MONTGOMERY COUNTY HISTORIC PRESERVATION COMMISSION
STAFF REPORT

Address:	17 Montgomery Avenue, Takoma Park	Meeting Date:	3/23/2022
Resource:	Outstanding Resource Takoma Park Historic District	Report Date:	3/16/2022
Applicant:	Kerry Richter (Scott Wilets, Architect)	Public Notice:	3/9/2022
Review:	HAWP	Tax Credit:	N/A
		Staff:	Michael Kyne

PROPOSAL: New rear addition, deck, and hardscape

Fig. 2: 1959 Sanborn Fire Insurance Map, with subject property outlined in red and altered and/or removed features highlighted in blue.

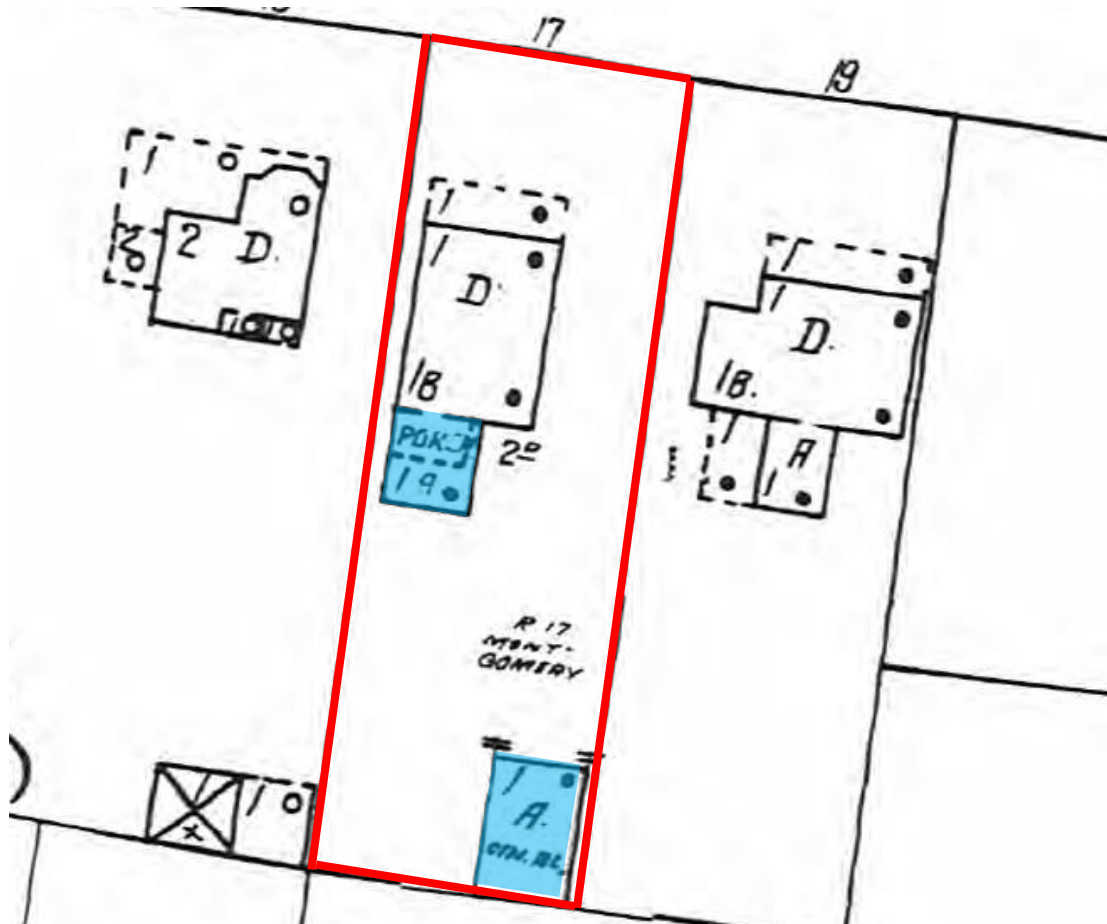
The subject property is a c. 1910s-20s Bungalow-style Outstanding Resource within the Takoma Park Historic District. The historic house has experienced previous alterations, including the enclosure of the two story open porch at the rear, the removal of an attached one story garage at the rear, and the removal of a non-original (not present in the 1927 Sanborn Fire Insurance Map) one story detached cinder block garage at the southeast (rear/right, as viewed from the public right-of-way of Montgomery Avenue) corner of the property (see *Fig. 2* below).
